# Difficult to Refuel Vehicle

### REVISION NOTICE

**June 1, 2018 Rev1:**

- **Applicability has been updated to include 2018 model year Camry HV, Prius, and Prius Prime vehicles.**
- **The entire bulletin has been updated.**

**Figure 2.**

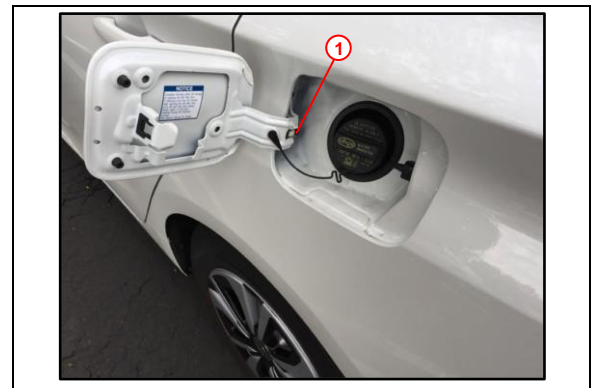
4. Replace the fuel filler opening door hinge spring.
  - A. Locate the spring.

<b>1</b>	<b>Fuel Filler Opening Door Hinge Spring</b>
----------	--

- B. Lightly pry up on the tab of the spring with the plastic pry tool (SST) and push the spring toward the inside of the vehicle to remove it.

**Figure 4.**

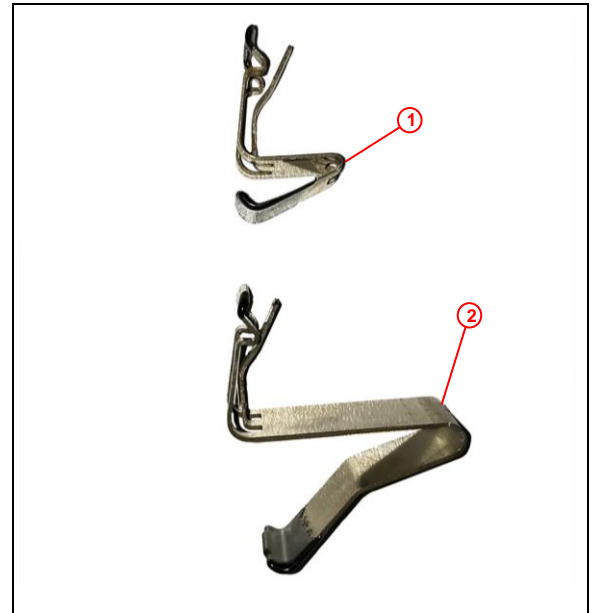
- C. Compare the original spring to the NEW spring to ensure that the NEW spring is installed.

The NEW spring is larger than the original spring.

1	Original Spring
2	New Spring

5. Install the NEW spring by pushing the spring into the fuel filler door until the tab is seated.
6. Confirm the repair.  
Ensure the fuel filler door opens completely when pressing the fuel door open button.

**Figure 10. Camry HV**

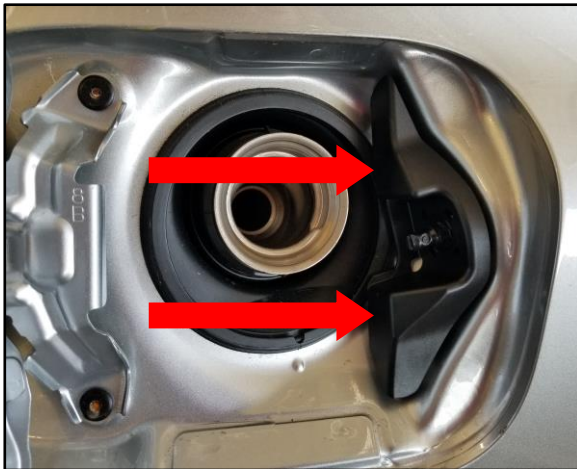
11. Install the fuel door lock switch cover.  
Line up the tabs on the retainer/cover and push the cover toward the rear of the vehicle until it locks into place.
